Engineers Comments Regarding Surface Water Drainage

Application Reference:	F/25/26/DOC	Reviewer Reference:	ADC/EXT4b
Planning Officer:	David Easton	Date of Review:	08/05/2026
Site Name:	Land at Ford Airfield Ford		
Application Description:	Approval of details reserved by condition under F/4/20/OUT relating to conditions 28- Foul Drainage, 29- Surface Water Drainage, 30- Discharge to Watercourses and 31- Maintenance & Management.		
Assessment Number:	1 of 2

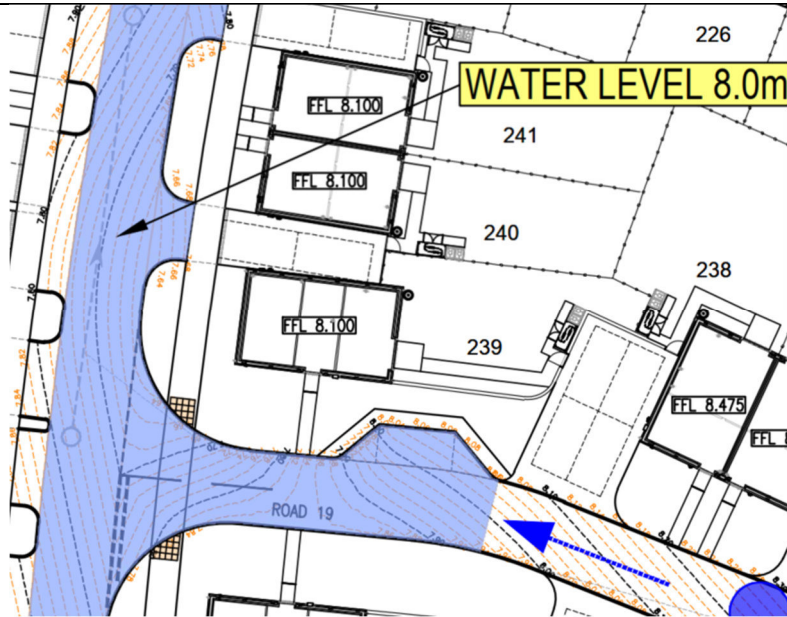
Technical Note (ref: C85228-JNP-92-XX-RP-C-1004) dated 9 July 2021 and the requirements of the Design Code secured under Condition 7. The JNP technical note states that the north/northwest parcels will drain using “parcel SuDS with overflows/connections to a piped sewerage system which discharges to an infiltration basin.” It is acknowledged that infiltration for this purpose has since been proven unviable, and also that ultimate discharge shall be to the northeast basin(s), however no ‘parcel’ suds have been provided. Paragraph 2.6 indicates that permeable paving will be provided for water treatment, none is shown on the drainage layouts. Paragraph 5.4 acknowledges that the permeable paving may be tanked if infiltration is not viable. Please update the design accordingly.

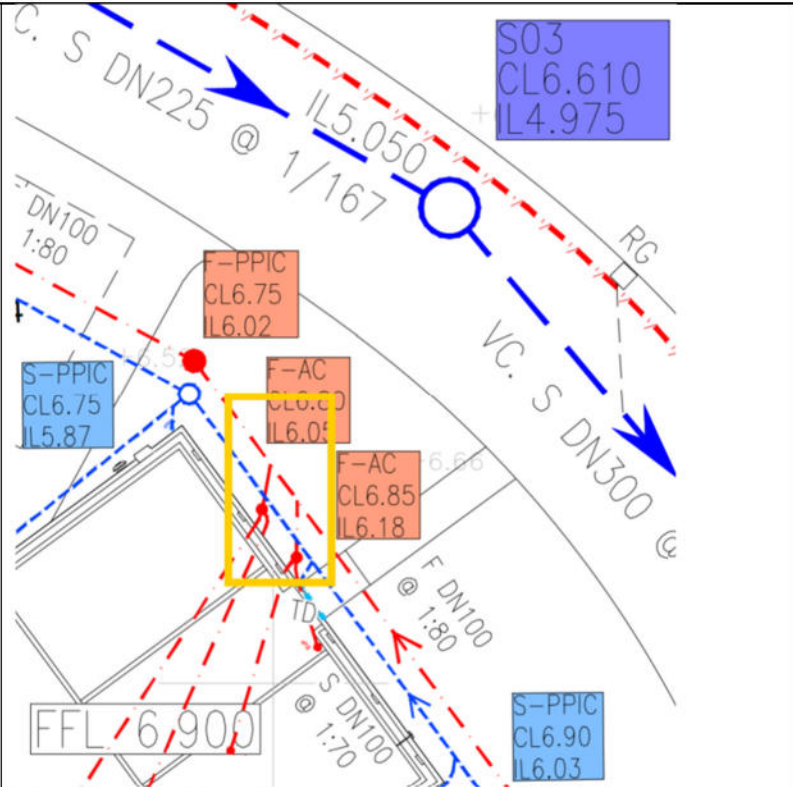
19.	On the revised exceedance plan please be clear about what event it represents. As per the 1% AEP +CC SW drainage flooding event plan please show any flood volume aligned to the contours and accounting for gullies. Example in snip below shows how the flood area is misrepresented and would in fact flow into plot 239 front garden and sit around house which is likely to have a FFL 150mm above ground level. This would be an unacceptable exceedance.
